DevNW Airport Road

Final Planned Unit Development (PUD) &
Final Subdivision Plat (SUB)
for proposed development of 12 affordable, single-family,
detached dwellings.

PC 20 17 PUD 02

PC 20 16 SUB 02

Landscape Plan

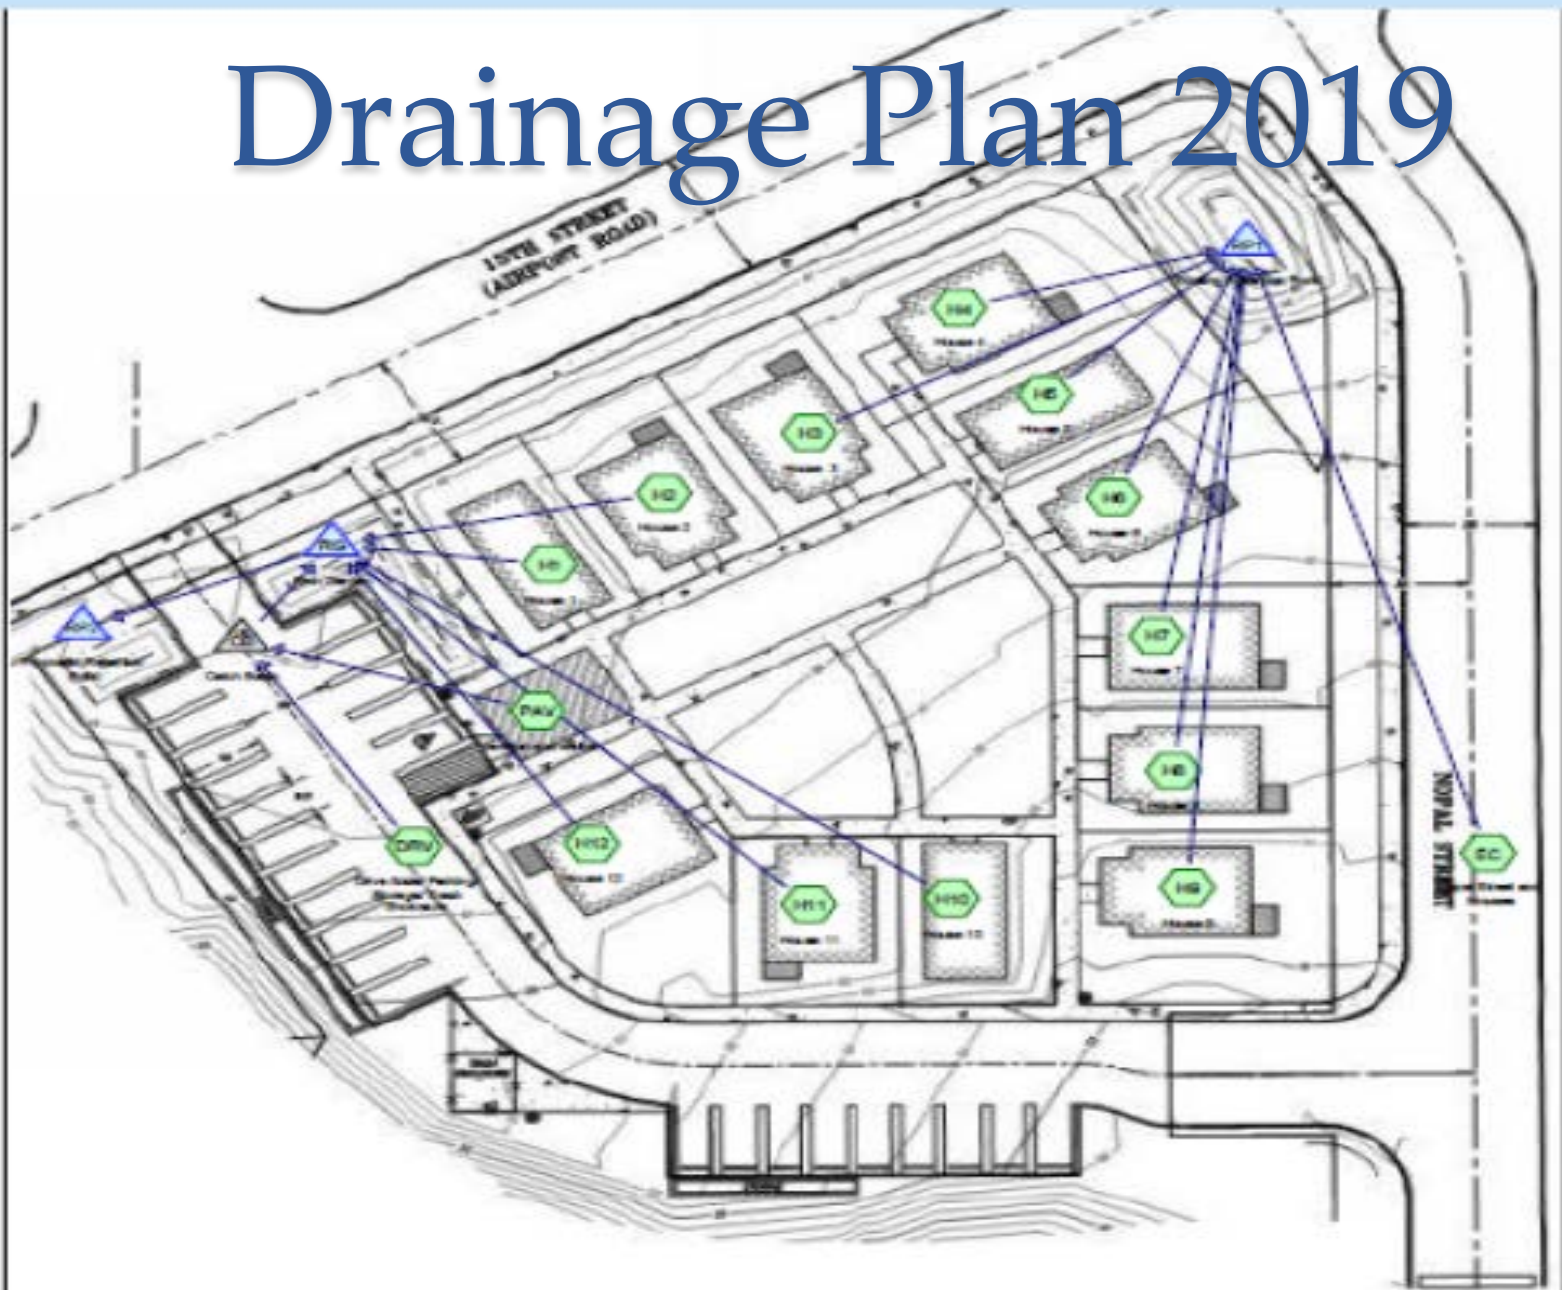
“The first relates to the schedule of planting on the south slope that they cleared. There does not appear to be a schedule of when that would be replanted or the types of vegetation that will be replanted. I believe that this needs to occur quickly to prevent erosion from occurring begin the summer winds begin. One of the main issues that was raised by myself earlier was the impact of clearing on adjacent lands. The developers ensured that vegetation on adjacent lands would be protected and planting as soon as possible is the only way to ensure that this is in fact the case. This is especially true on near the tops of the slopes where large trees and rhododendrons had previously stabilized the bank”

4. The applicant shall amend the Landscaping Plan to (a) include landscaping/irrigation notes for the 10' buffer area between the western property boundary and the parking lot and (b) provide vegetation in Tract C of the proposed development in order to retain the slope. Such vegetation shall be plantings that quickly establish root systems to ensure stability of the slope.

6/9/2020 Drainage Plan

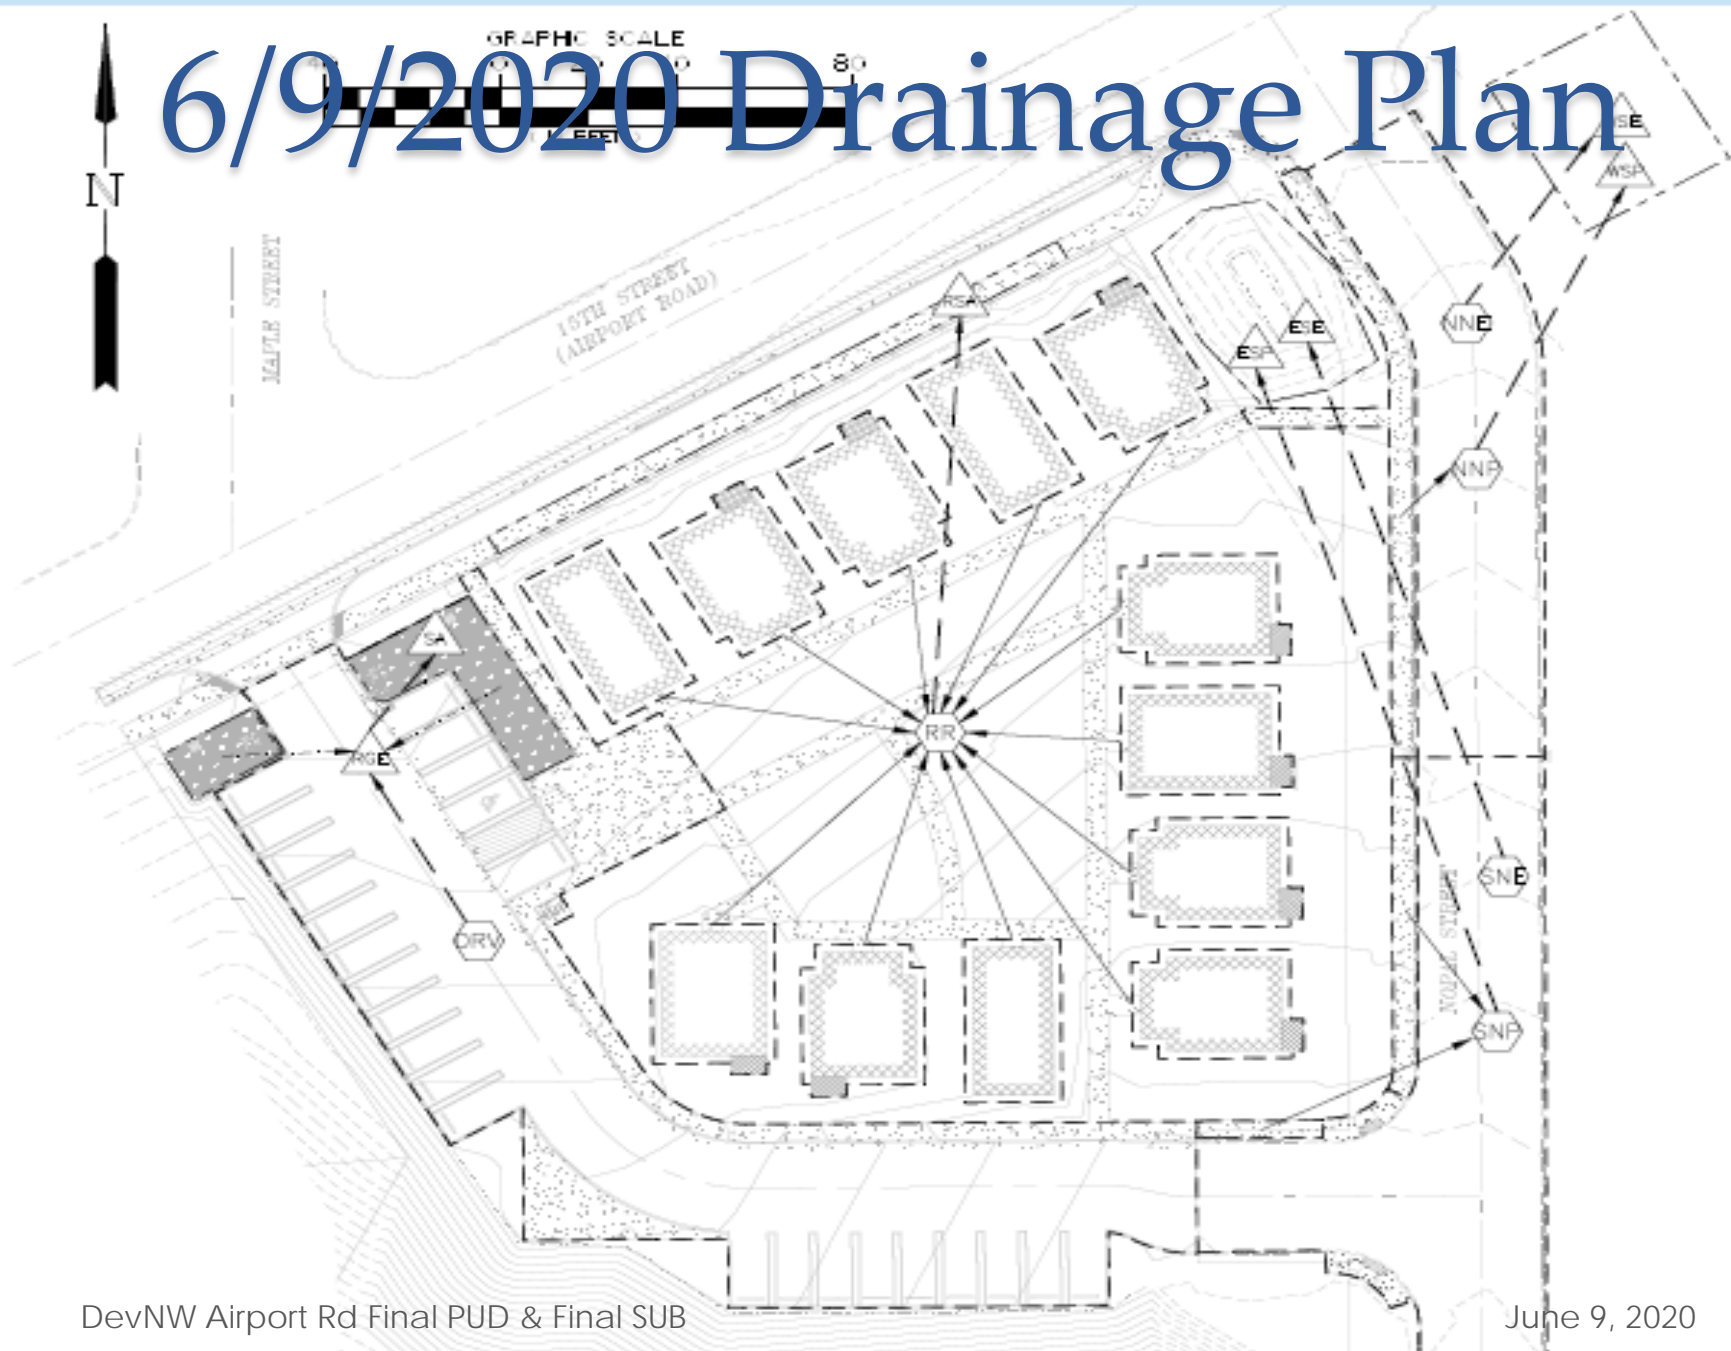
- On the approved plans, they proposed a stormwater facility along the Airport Road frontage to handle both street runoff and their private roof drain runoff. However, the existing water main is very shallow and conflicts with the planned stormwater facility. We determined that it was in the best interests of the developer and the City to not require the relocation of the water main at this time. In the City's 20-year capital improvement plan the existing 6-inch water main will be replaced with a 12-inch water main. Again, that will take place sometime in the next 20 years. The change will be noted on the as-built plans and will not require additional revisions to the public improvement plans.

- What we agreed to was the elimination of the stormwater treatment facility (the portion that would have treated the stormwater runoff from the street) and continue to allow the stormwater to run along the gutter line and enter the storm system as it does today. The sidewalk will remain property tight (the back of sidewalk at the property line) with a planter strip between the sidewalk and back of curb. We will have them enter into a private use of public right-of-way agreement to locate their roof drain infiltration systems within that area. In the future that may need to change if Airport is fully widened to allow on-street parking.

5. Due to a recent discovery regarding how rooftop drainage is conveyed to Airport Rd./15th St, the stormwater leaving the private on-site facilities shall reflect that it will collect in a facility in the public right-of-way. As such, the applicant shall submit a draft Memorandum of Understanding for responsibility of the surface and subsurface maintenance and future relocation of this private stormwater facility. The CC&R's shall also reflect the responsibility of the future HOA in maintaining the public stormwater facility. Such memorandum shall be submitted to the Planning Department and recorded with Lane County Deeds and Records.

Lighting Plan

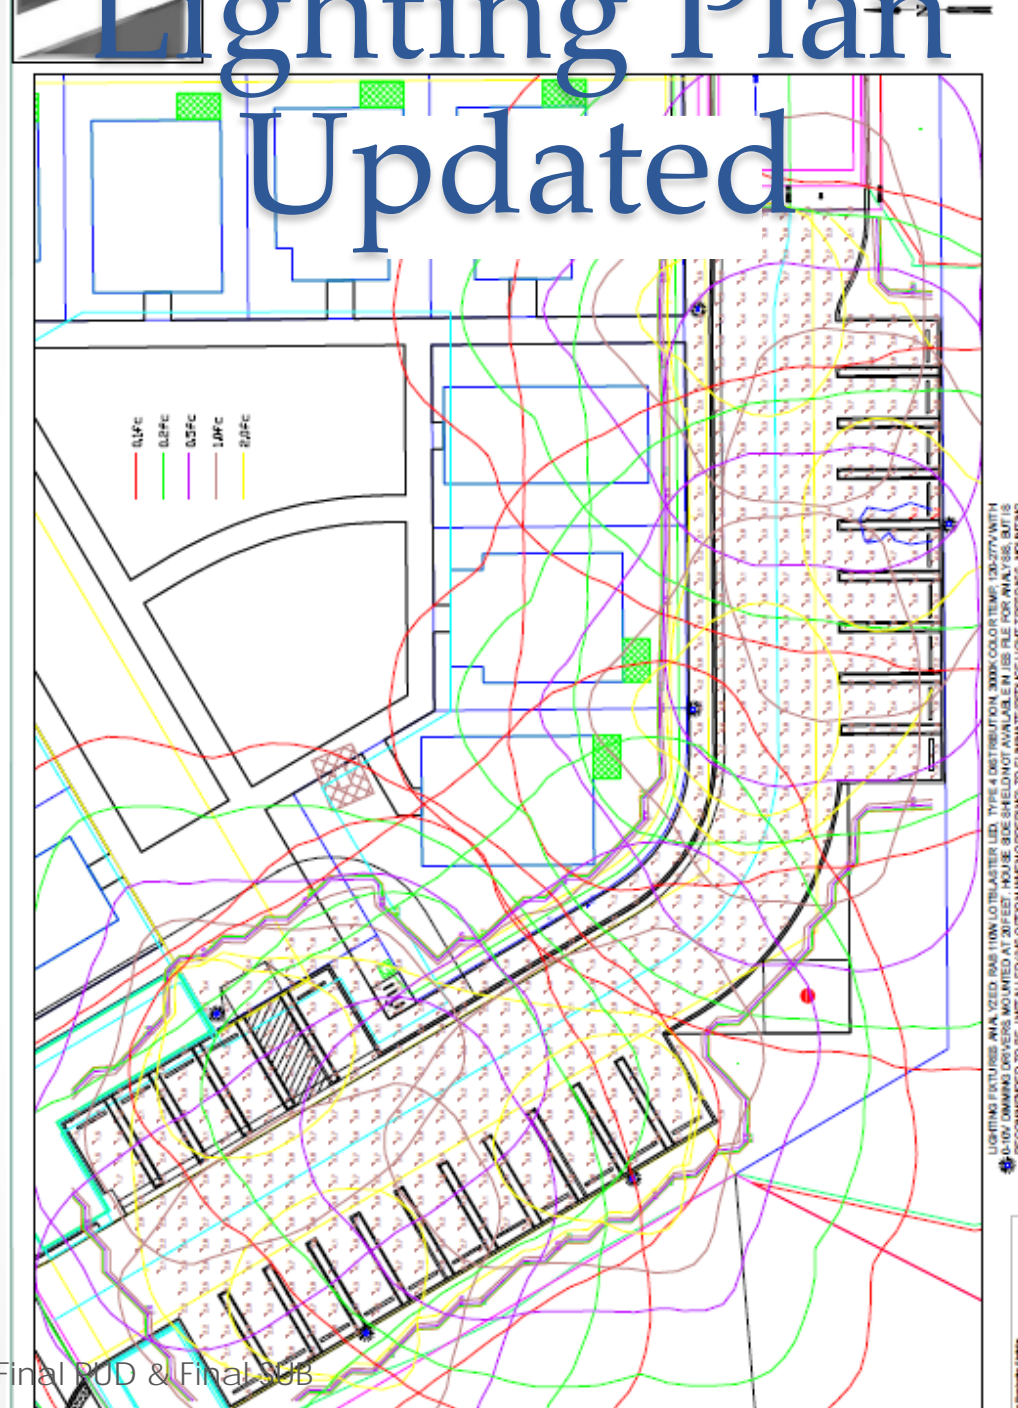
“My second point is that the clearing that was done has removed a large amount of the vegetation that blocked sightline into the development from the west. The plans currently show lights that will shine light in all directions, I want to make sure that the lights that are installed do not shine onto my property and into my windows. The lights should be shielded to prevent spill over of light into the lots to the west and south.”

8. The applicant shall have the photometric plans amended to illustrate that lighting remains internal to the development.
